11n 3X3 Mini PCIe Card (BCM43431)

Model Name		EAP1028B-25-0714-EC	Rev	R02
Size	C	Page Name	Engineer	
		Title Page	Erick Chen	
Date:		Friday, October 30, 2015	Sheet	1 of 5

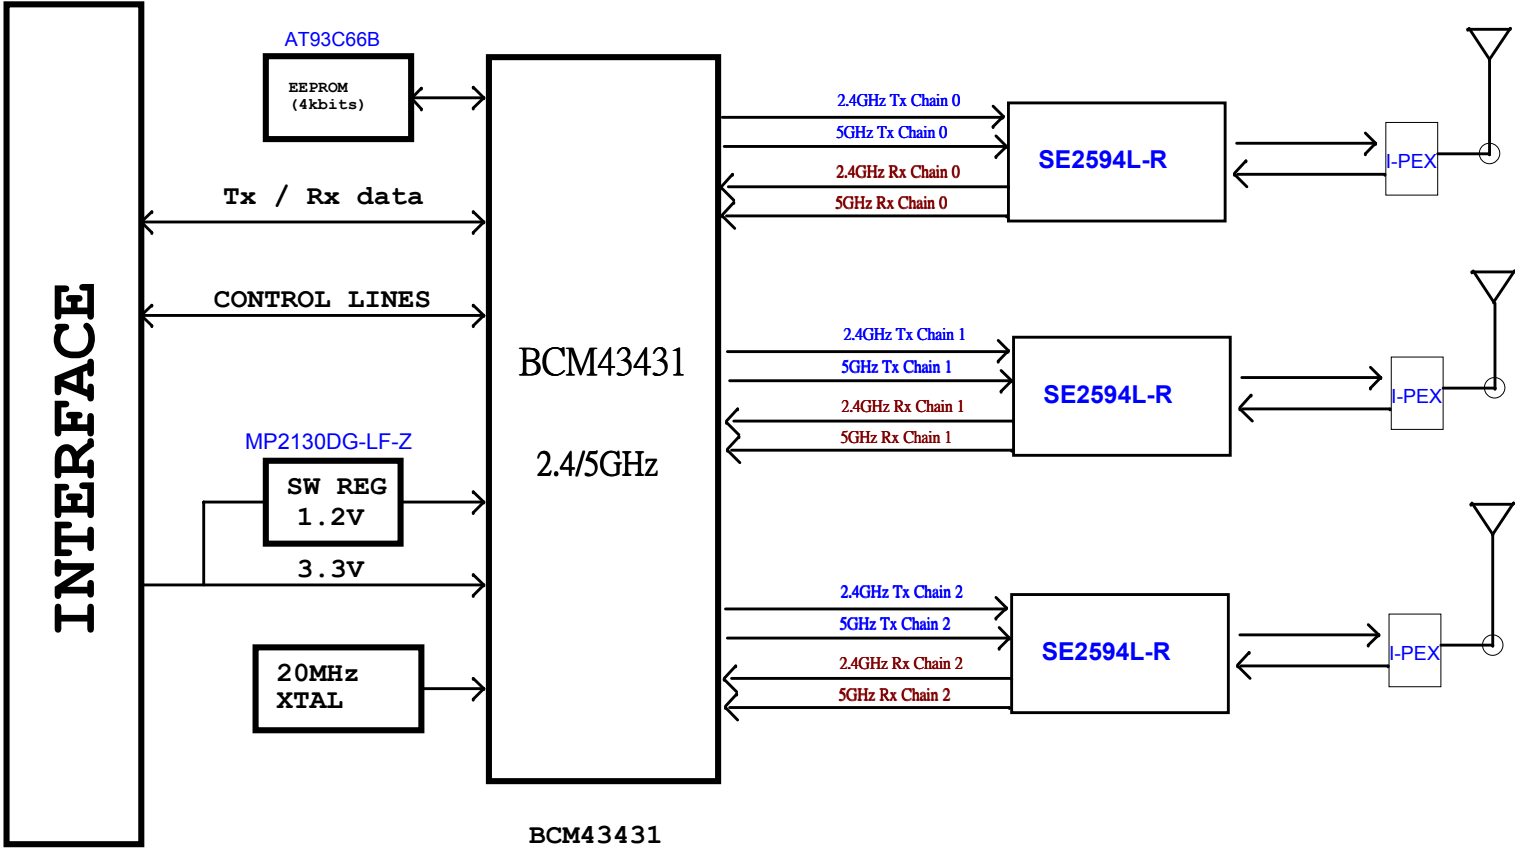
Version	Date	Change Description
R0A	2013/09/09	This schematic is based on BCM43431MC P130 design
R01	2014/06/25	change discription from R0A to R01
R02	2015/09/03	change U14 from AAT2114IVN-0.6-T1 to MP2130DG-LF-Z change R120 from 60.4K to 200K. change R119 from 59K to 196K.
